## IPS224TA/IPS234TA

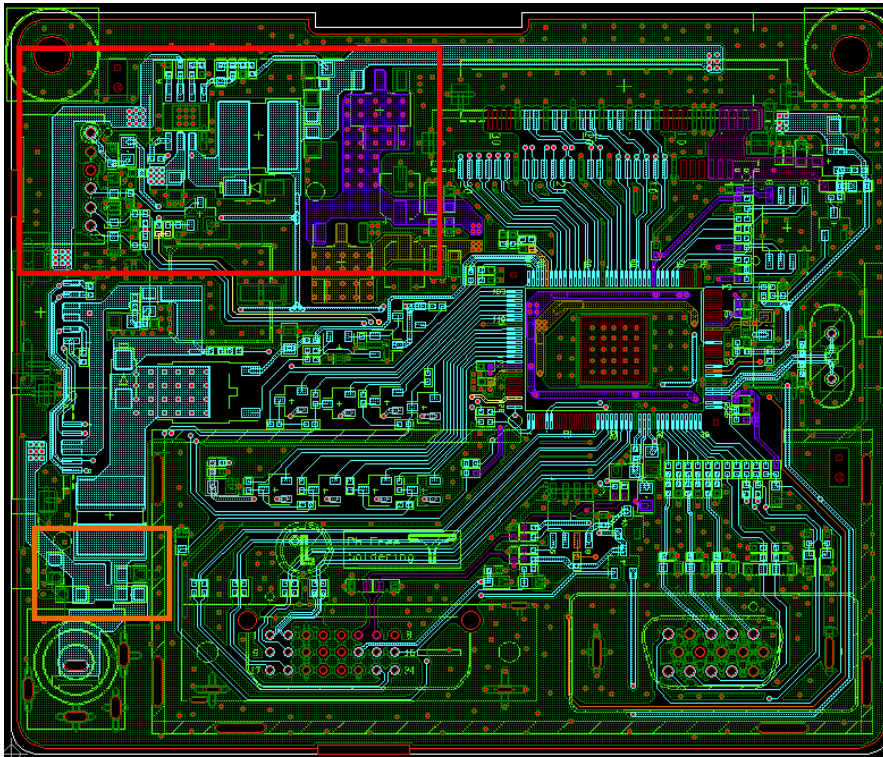
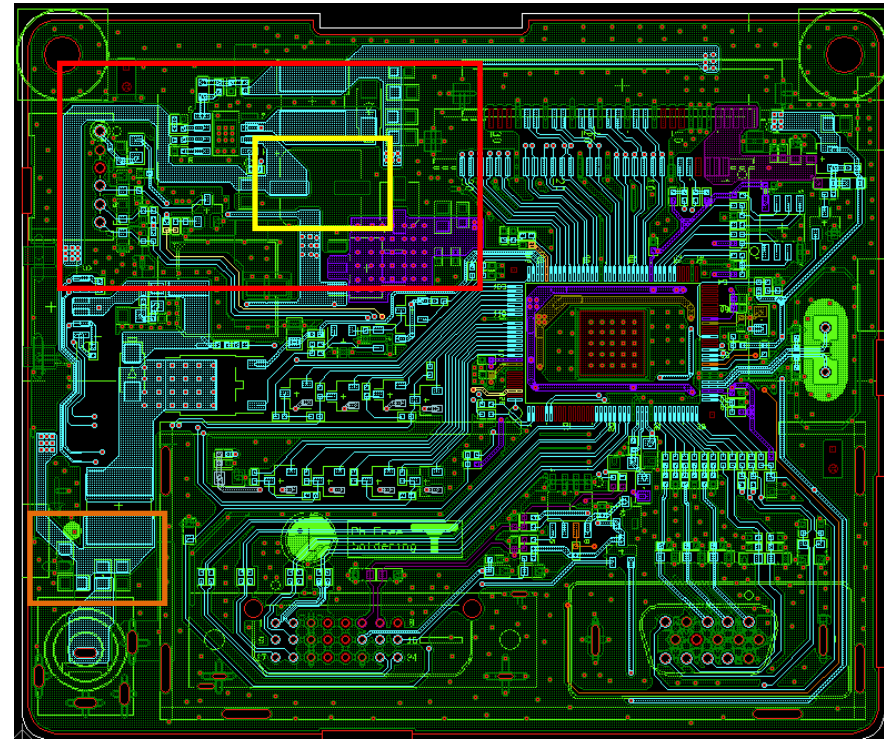
1. Yellow area for the new capacitor, which leads to the red area LAYOUT change
2. Orange area consists of two transverse resistance, into two vertical resistance
